Council Agenda Report

Subject: Appeal No. 21-004 - Appeal of Planning Commission Resolution No. 21-15 (33603 Pacific Coast Highway; Owner/Appellant, Palms of Malibu Ranch, LLC / Lauren Coffman)

DISCUSSION: The matter is an appeal of the Planning Commission's denial of CDP No. 16-025, an application for a proposed two-story, single-family residence and other associated development.

Subject: Coastal Development Permit No. 16-025, Variance Nos. 16-013 and 16-014, Site Plan Review Nos. 16-028 and 20-078 and Demolition Permit No. 19-047 – An application for the construction of a new two-story single-family residence, demolition of existing single-family residence, exterior façade remodel of existing guest house, and associated development

Figure 3 – Remedial Grading Areas

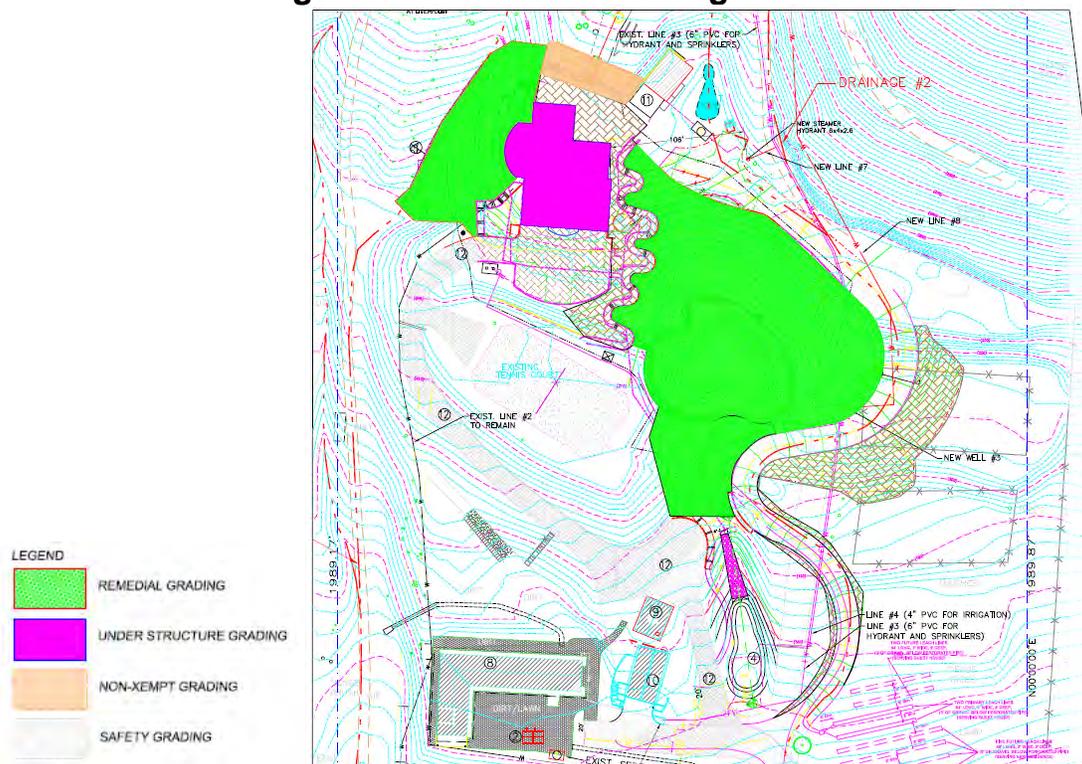
The LCP requires that the City make findings in the consideration and approval of an SPR for remedial grading. The project includes SPR No. 20-078 for remedial grading due to the existing slope conditions not having adequate safety factors that would meet current requirements of the City’s geotechnical guidelines, corrective grading is required to create a suitably safe slope condition. The site plan review for remedial grading will allow the applicant to reconstruct the slope to meet the current city criteria for safe engineered slope conditions as required by city geotechnical staff (Figure 3 – Remedial Grading Areas). Based on the evidence contained within the record, Planning Department staff recommends the approval of SPR No. 20-078.

COMPLIANCE WITH 2/3RDS RULE

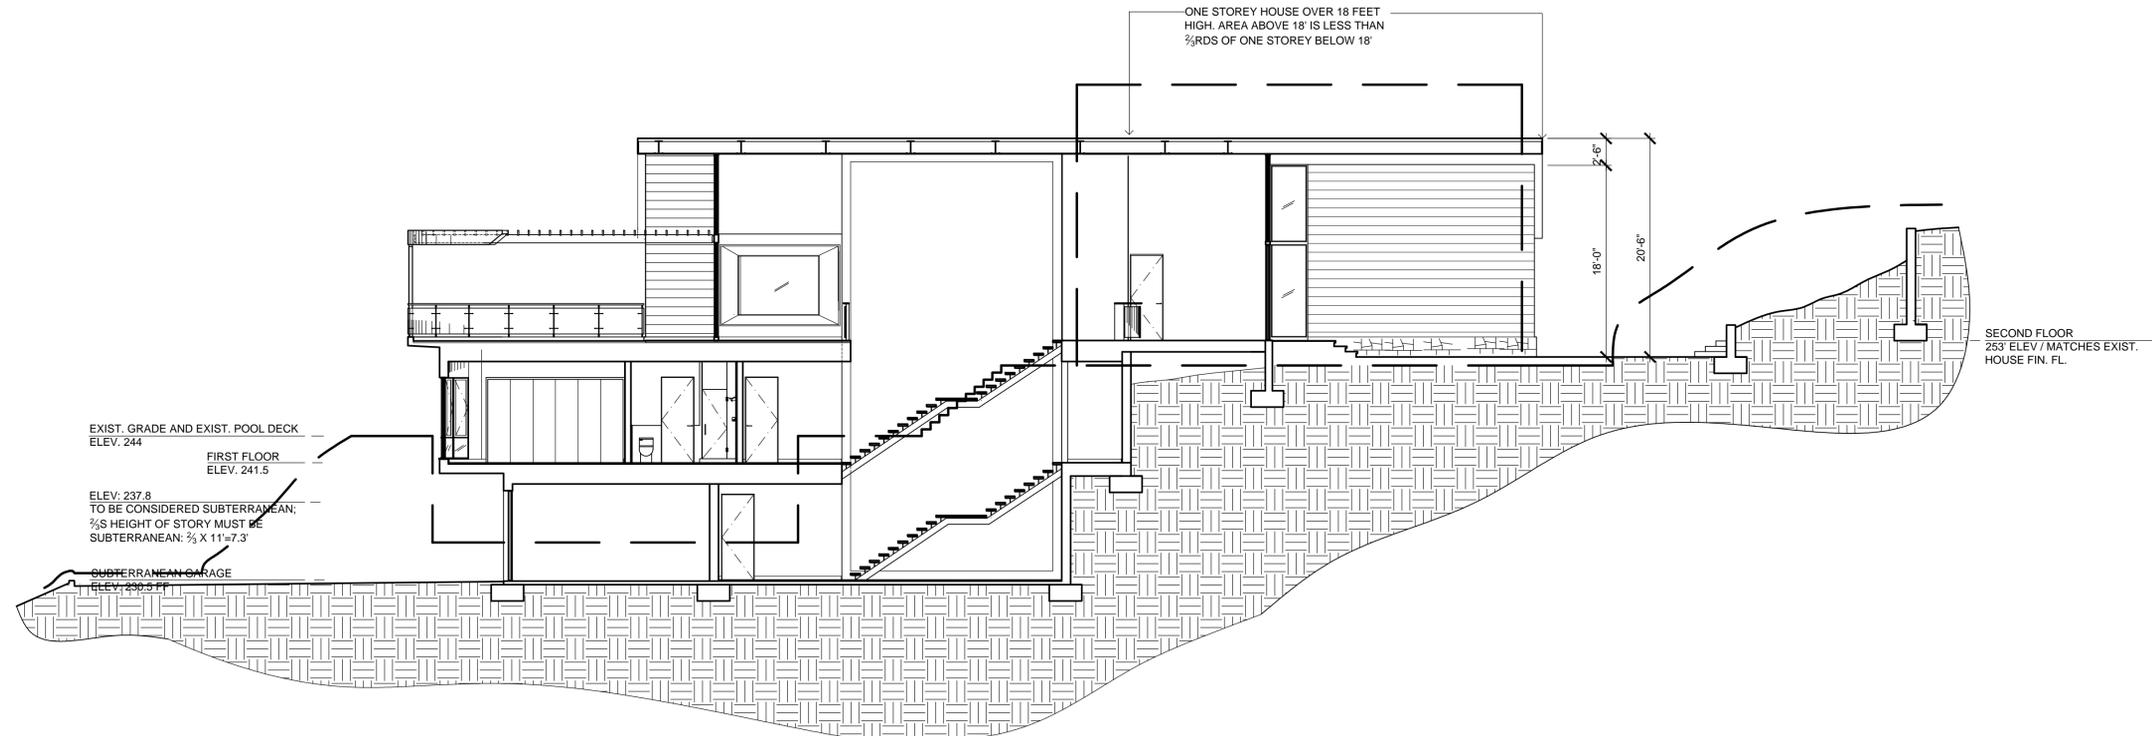
³ To be clear, as demonstrated in the attached Planning Commission Agenda Report the proposed project in fact complies with the 2/3rds rule (LIP Section 3.6(K)(2)). In addition, the geotechnical reports that recommend remedial grading were reviewed by the City's geotechnical staff and it was determined that the proposed remedial grading is required and complies with the City's geotechnical guidelines. In addition, the proposed subterranean garage is consistent with LIP Section 3.6(K)(4) "A subterranean garage shall be allowed only one opening for vehicular ingress and egress with a maximum continuous width of thirty-six (36) feet ..." Lastly as discussed, based on the building permit history the previous grading plus proposed grading is consistent with the 1,000 cubic yards limitation placed on non-exempt grading.
